IHS Whiteriver Hospital

ISSUED FOR	DATE
BID ADDENDUM-C	14MAY26
BID ADDENDUM-A	16APR26
FINAL CONSTRUCTION DOCUMENTS	05MAR26

SHEET TITLE
GENERAL NOTES & DESIGN DATA

FIGURE SA-5(R)
LANE CLOSURE (RIGHT LANE) - DIVIDED HIGHWAY

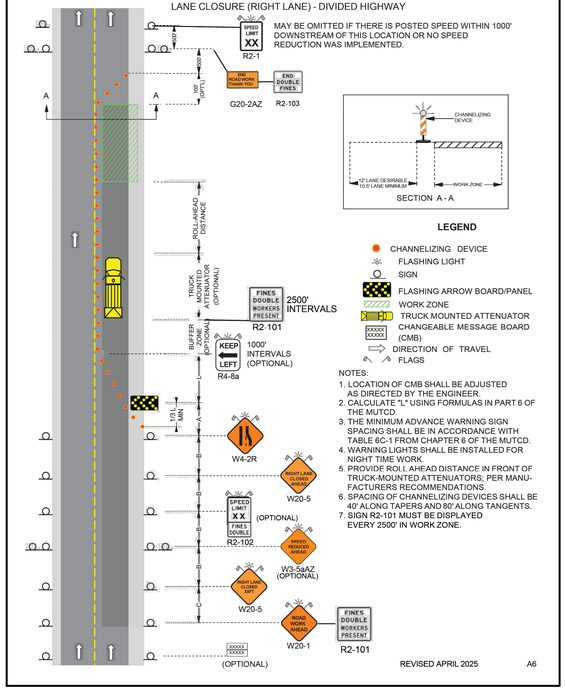
4 Δ C

R2–102 (35)
48"x60"
BLACK ON WHITE

5 Δ C

R2–102 (45)
48"x60"
BLACK ON WHITE

PHASE 2
MUTCD FIGURE TA–3

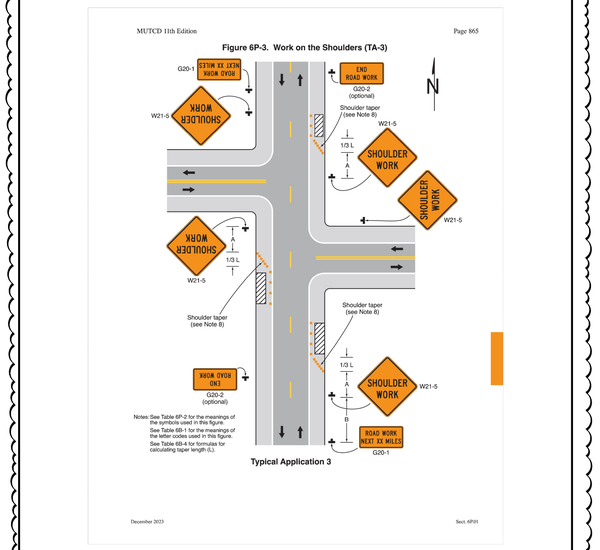
Δ C 1. THE TABLE ABOVE WAS DEVELOPED BASED ON VALUES PRESENTED IN TABLES 6B–1, 6B–3, AND 6B–4 OF THE 2023 MUTCD.
